**NRC STAFF RESPONSE TO PUBLIC COMMENTS ON
NUREG/CR-7002, REVISION 1, “CRITERIA FOR DEVELOPMENT OF
EVACUATION TIME ESTIMATE STUDIES”
85 FR 52930 (August 27, 2020)**

On August 27, 2020, the U.S. Nuclear Regulatory Commission (NRC) issued for public comment in Volume 85 of the *Federal Register* (FR), page 52930 (85 FR 52930), draft NUREG/CR-7002, “Criteria for Development of Evacuation Time Estimate Studies,” Revision 1 (Agencywide Documents Access and Management System (ADAMS) Accession No. ML20233A700). The FR notice provided a 45-day public comment period, which expired on October 13, 2020. Comments on the subject NUREG are available electronically in the NRC’s electronic Reading Room at <https://www.nrc.gov/reading-rm/adams.html>. From this page, the public can enter ADAMS, which provides text and image files of the NRC’s public documents.

Figure 7-5. Congestion Patterns at 4 Hours after the Advisory to Evacuate

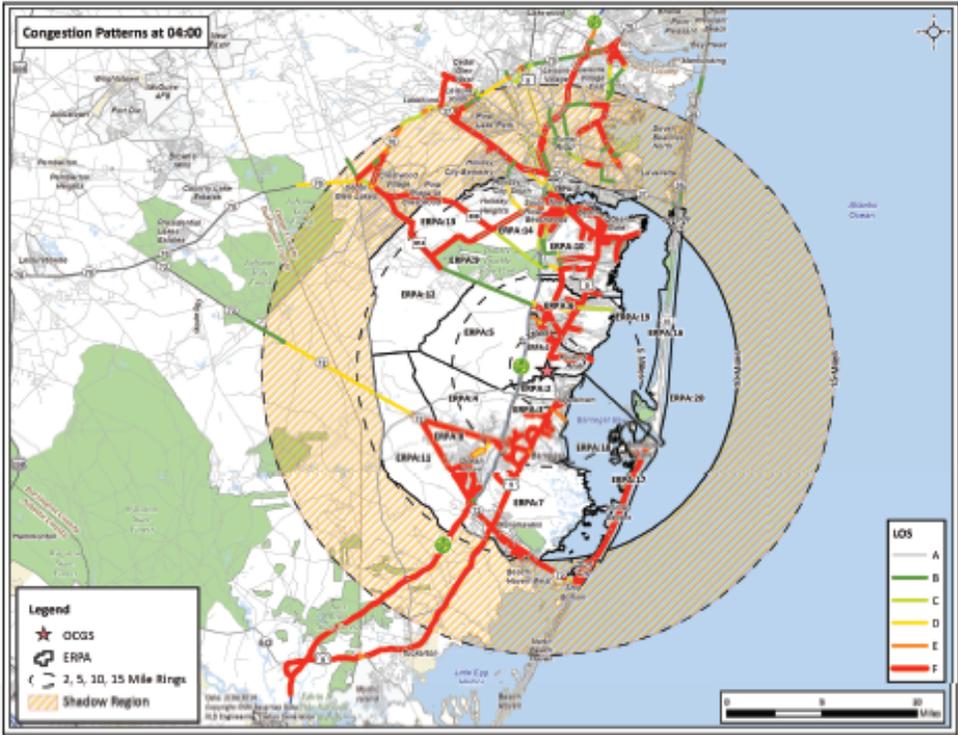
Staged Evacuation—Section 1.4.1—Pages 1-9, 1-10

Lines 11 through 14 read “If the site-specific PAR logic addresses staged evacuation, then the licensee should include in the ETE study a discussion on the approach used in the development of staged evacuation scenarios. Licensees should include a staged evacuation analysis for initial PAR strategy development as described in Section 5.6.” This is the proverbial “putting the cart before the horse.” The ETE study is supposed to inform the PAR. If the ETE study deems staged evacuation to be beneficial to those people living in the 2-mile region, then the licensee and OROs should include staged evacuation in their PAR logic if they feel it can realistically be implemented. By saying staged evacuation analysis should be done if it is in the existing PAR logic, you are relying on PAR logic that was developed after the last full ETE study. What if the population in the 2-5 mile area has drastically changed in the last decade (this is happening in Florida and the Carolinas) and staged evacuation is now beneficial based on population distribution when it was not beneficial a decade earlier? The original version of NUREG/CR-7002 (dated November 2011) required a staged evacuation analysis for all sites. Nearly all sites showed no benefit from staged evacuation (after a rigorous quantitative analysis) after the 2010 Census. We recommend the following approach for determining whether staged evacuation analysis should be further considered for a site in the new guidance document. Run an ETE simulation for an evacuation of the full EPZ for the scenario (non-special event) that has the highest number of evacuating vehicles. If the simulation indicates traffic congestion (Level of Service F) and queuing that extends from outside the 2-mile region into the 2-mile region, it clearly shows that evacuation beyond the 2-mile region is delaying the egress of people within the 2-mile region. If that occurs, then a quantitative analysis of staged evacuation (comparing ETE with and without staged evacuation) should be done. This is the fundamental idea of staged evacuation...get the people in the 2-mile region out as quickly as possible. It should only be considered for sites where it is a valid concern. As an example, Oyster Creek Generating Station is one of the few sites that exhibited an ETE benefit of staged evacuation after the 2010 Census. Attached is Figure 7-5 from the Oyster Creek ETE report which shows traffic congestion on US Highway 9 northbound that extends from the EPZ boundary into the 2-mile radius just north of the plant at 4 hours after the advisory to evacuate. Clearly, in this example, evacuation of the 2-mile radius is hindered by evacuation of those beyond 2 miles and further analysis of staged evacuation is needed.

The NRC agrees with the comment. The evacuation time estimate (ETE) should inform the protective action recommendation (PAR) strategy. And the draft guidance could be interpreted not to consider staged evacuation which is not the intent. The guidance in NUREG/CR-7002 needs to support that in NUREG-0654, Supplement 3, “Criteria for Preparation and Evaluation of Radiological Emergency Response Plans and Preparedness in Support of Nuclear Power Plants: Guidance for Protective Action Strategies,” (ADAMS Accession No. ML113010596) for the development of PAR strategies. Staged and keyhole evacuation ETEs should be evaluated as per the original issue of NUREG/CR-7002. The staff removed the conflicting statement on lines 11 through 14 in Section 1.4.1. The staff also revised Section 1.4 to reflect the original guidance and development of keyhole and staged evacuation ETEs, but also to reflect variable sized emergency planning zones. Changes were made to Section 4.7 to conform with the revised bulleted list of Section 1.4. Finally, the staff added headers for Section 1.4.1 on keyhole evacuations and Section 1.4.2 on staged evacuations to clearly distinguish those parts of the guidance.

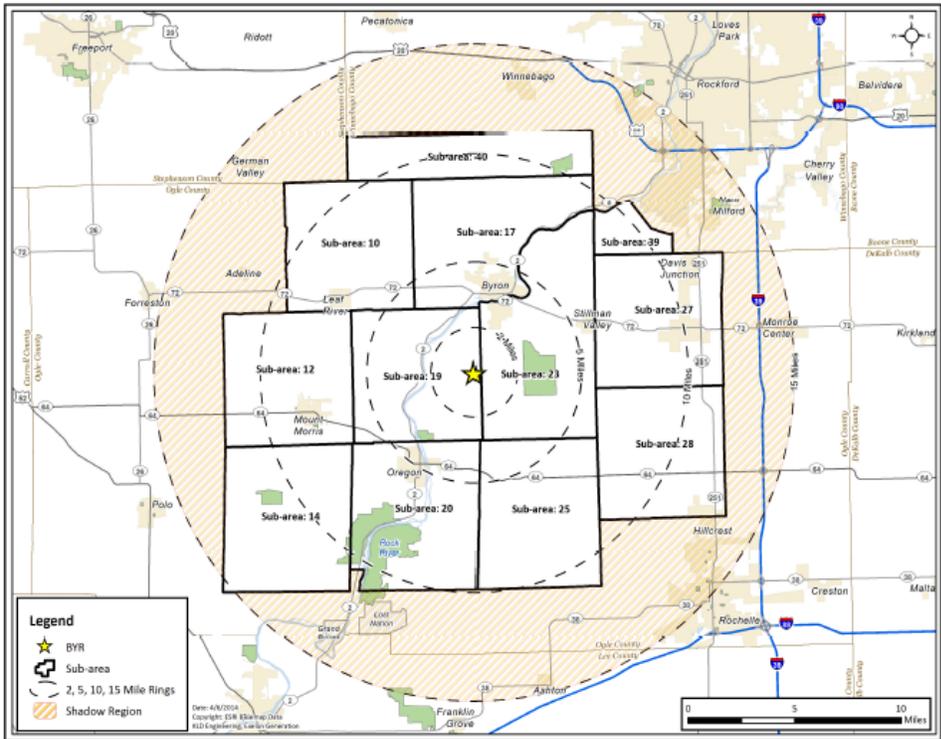
Shadow Evacuation—Section 2.5.2—Pages 2-5 through 2-7

Lines 40 through 42 read “... in some cases, the shadow region may need to be extended to include the influence of major population centers as shown in this figure.” Please provide more specific guidance. What defines a “major population center”? Population exceeding 20,000 people, 50,000 people, etc.? Also, Figure 2-2 shows the major population center intersecting the

EPZ Shadow Region. Should the Shadow Region be extended to include the major population center only when it intersects the recommended Shadow Region ("at least half the radial distance of the evacuation area"), or should it also be considered if the major population center is near the recommended Shadow Region? Also, how much of the major population center needs to be considered? If the population center intersects the recommended Shadow Region and extends an additional 5-miles beyond the Shadow Region, does the whole population center need to be considered? We understand that it is an engineering judgment call as to whether a nearby population center should be considered and how much of it should be considered. We would just like a bit more guidance on this subject to ensure the guidance is interpreted commonly by all who may use it.

The NRC agrees with the comment. The guidance is based on 1-mile buffers throughout. Capacity reductions and populations centers, if included, should extend the model, locally, about 1 additional mile along major evacuation routes of interest. Task 2 and Task 4 of the ETE Study (NUREG/CR-7269) indicate there is a very high threshold for when population centers outside the emergency planning zone (EPZ) would impact the ETE. This threshold is reached for population centers with populations approximately 4 times greater than the number of EPZ evacuees, based on the ETE study. The staff revised Section 2.5.2 to define the 50,000 evacuees more clearly as based on the permanent resident and transient populations within the EPZ. The staff also added a discussion on the insensitivity of the shadow analysis for EPZs with less than 50,000 evacuees. Finally, the staff revised the guidance to reference Section 4.5 to state when the model boundaries may need to be extended an additional mile due to capacity reductions or the presence of population centers.

Byron Shadow Region

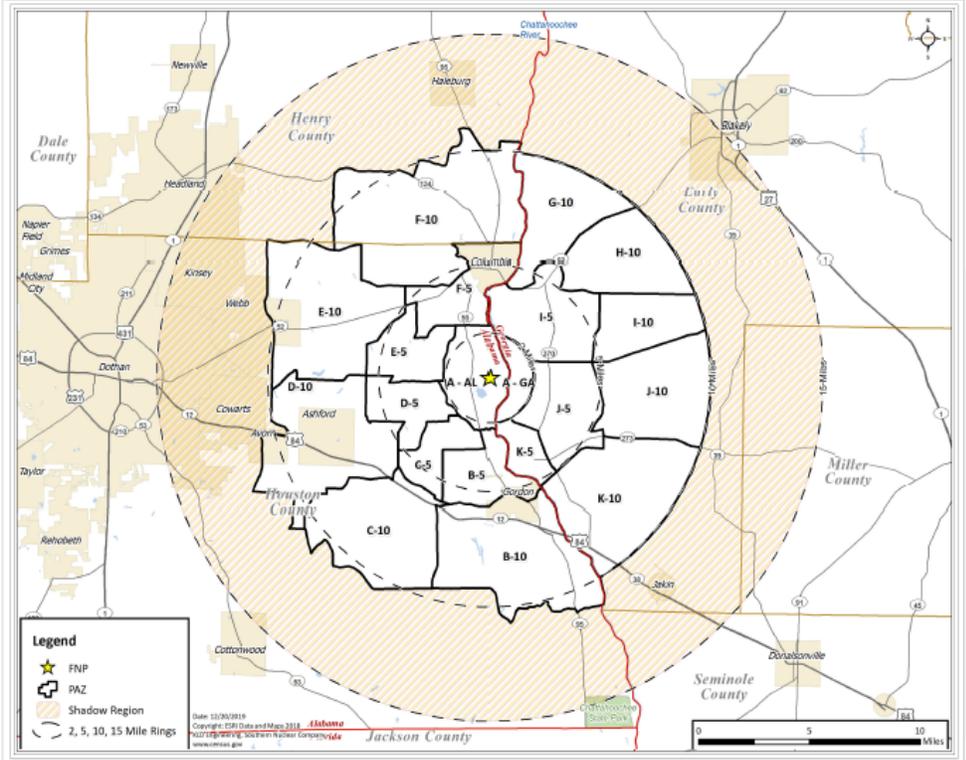
Shadow Evacuation—Section 2.5.2—Pages 2-5 through 2-7

Lines 40 through 42 on page 2-5 "... in some cases, the shadow region may need to be extended to include the influence of major population centers as shown in this figure" and lines 5 through 7 on page 2-7 "ETE studies do not need to model a shadow evacuation if the number of evacuees is less than 50,000 and 20 percent of the shadow population is less than half of the evacuating population" could conflict with one another for some sites. We offer two examples: (1) Byron Generating Station – the EPZ population as per the 2010 Census was 29,116 people (less than 50,000). The population in the Shadow Region (from EPZ boundary to 15 miles) was 34,644, 20% of which is 6,929 people, which is less than half of the evacuating population in the EPZ. Based on the page 2-7 criteria, a Shadow Region does not have to be considered for this site. However, as shown in the attached figure, the City of Rockford, IL intersects the 15-mile radius. The population of Rockford was approximately 152,000 people per the 2010 Census. A city that densely populated could impact ETE for the Byron Generating Station and should likely be considered as part of a shadow evacuation for the site. (2) Plant Farley - the EPZ population as per the 2010 Census was 10,707 people (less than 50,000). The population in the Shadow Region (from EPZ boundary to 15 miles) was 20,402, 20% of which is 4,080 people, which is less than half of the evacuating population in the EPZ. Based on the page 2-7 criteria, a Shadow Region does not have to be considered for this site. However, as shown in the attached figure, the City of Dothan, AL intersects the 15-mile radius. The population of Dothan was approximately 65,500 people per the 2010 census. A city that densely populated could impact ETE for Plant Farley and should likely be considered as part of a shadow evacuation for the site.

The NRC partially agrees with the comment. Tasks 1, 2, and 4 of the ETE Study (NUREG/CR-7269) and a review of 2010 ETEs would not suggest that Rockford and Dothan would impact the ETE. However, Task 2 of the ETE study highlighted issues of route choice and Task 4 has examined the impact of background traffic. Both analyses would indicate there is a very high threshold for when population centers outside the EPZ would impact the ETE. This threshold is reached for population centers with populations approximately 4 times greater than the number of EPZ evacuees (for EPZs with more than 50,000 evacuees), based on the ETE study. This compares well with the information provided in this comment that suggests that cities with populations 5 to 6 times greater than the EPZ resident population may influence the ETE. However, the results of the ETE study indicate that for EPZs with less than 50,000 evacuees, the ETE is relatively insensitive to regions outside the study area. The staff revised Section 2.5.2 to define the referenced 50,000 evacuees more clearly as based on the permanent resident and transient populations within the EPZ and added a discussion on the insensitivity of the shadow analysis for EPZs with less than 50,000 evacuees. The staff also added guidance in Section 2.5.2 referencing Section 4.5 to address establishing boundary conditions for larger population sites (EPZs with more than 50,000 evacuees). Finally, the staff added clarification in Section 4.5 that boundary conditions are more important along major evacuation routes and for large population sites.
